HOLY CROSS COLLEGE - STAGE 1 ROAD SAFETY AUDIT PREPARED BY BARRY TRANSPORTATION

Clonliffe Lands Development Access Junctions

Stage 1 Road Safety Audit

February 2021

Figure 2.1: Secondary Primary Heads

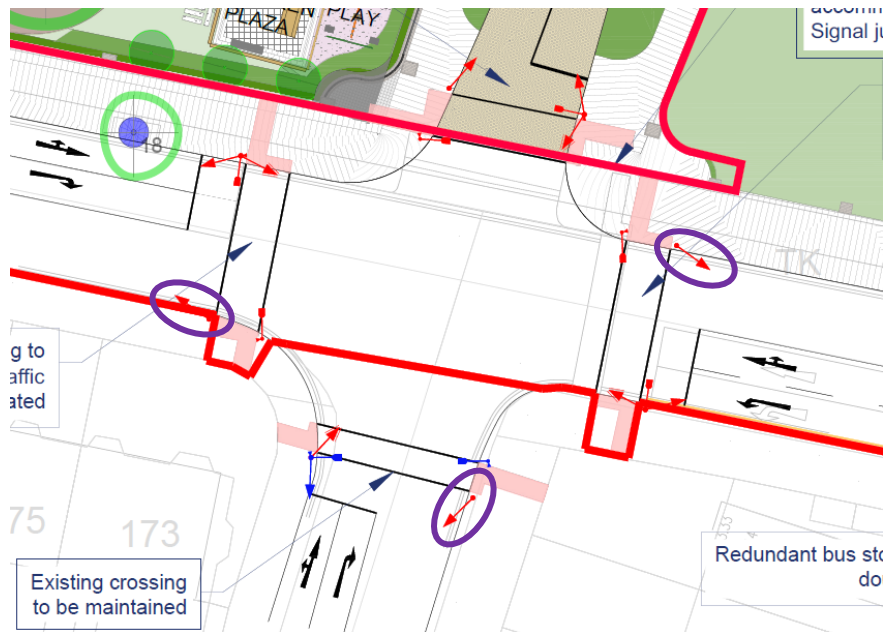
The proposed traffic signals at the Clonliffe Road / Jones' Road junction with the development are inconsistent with the traffic signal arrangement at similar nearby junctions within Dublin City Council. The proposed arrangement includes a primary head, secondary head and a second primary head for each arm. The second primary head is not required at a junction of this nature. See Figure 2.1 of the proposed arrangement and Figure 2.2 for examples of similar junctions near Clonliffe Road with no secondary primary head.

Remove the second primary head at the junction.
